Project #: 62438.00

Re: Windmill 27 Proposed Traffic Study Methodology
Comment Responses

Re: Windmill 27 Proposed Traffic Study Methodology

FIGURE
1

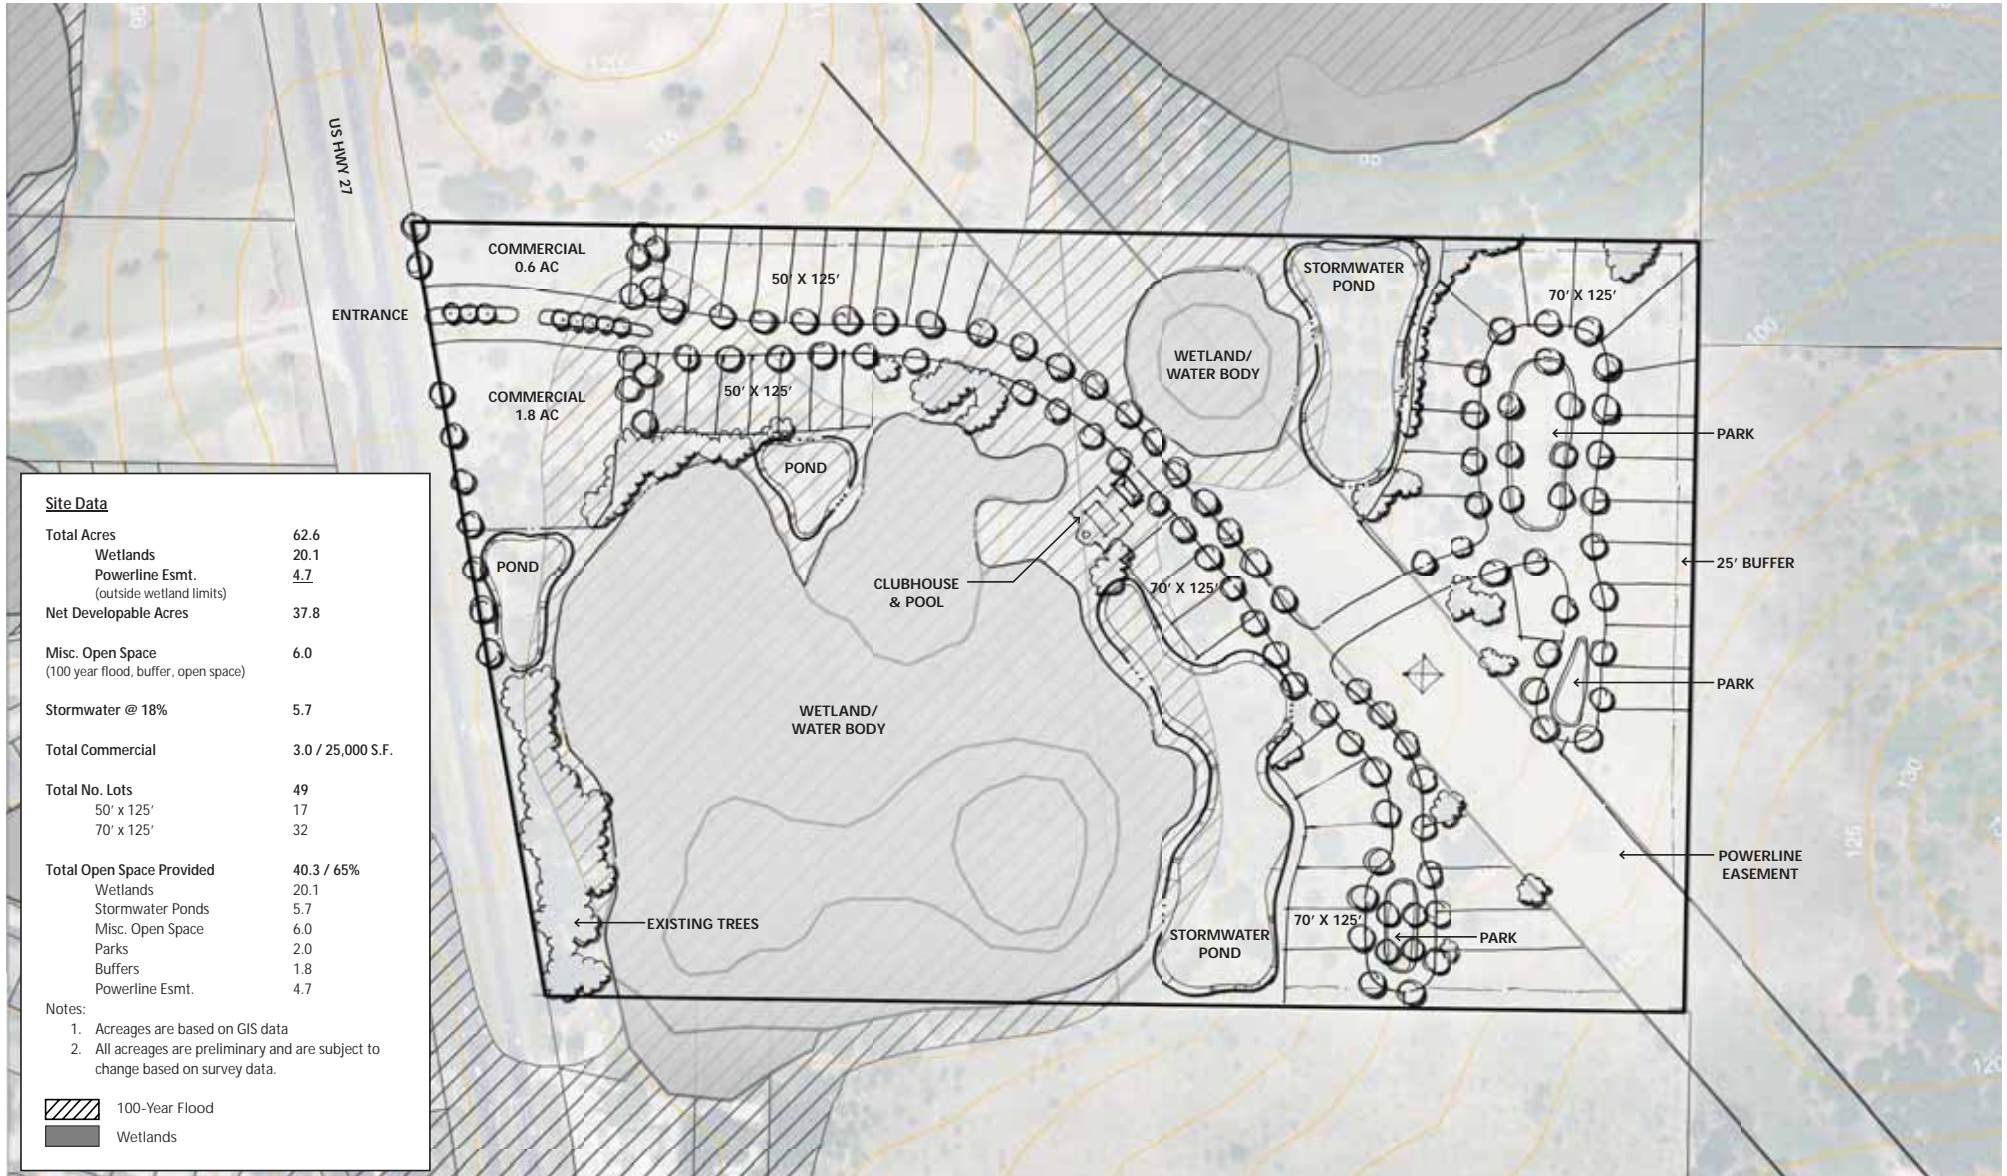
Comment #2 - The methodology states that the development program is 250 single-family dwelling units; however, the concept plan shows 49 single-family dwelling units. Please confirm.

Response: The traffic study is being prepared in support of a Future Land Use Map amendment; therefore, the maximum development potential of the site is used in the analysis to determine the worst case scenario impacts to the roadway network.
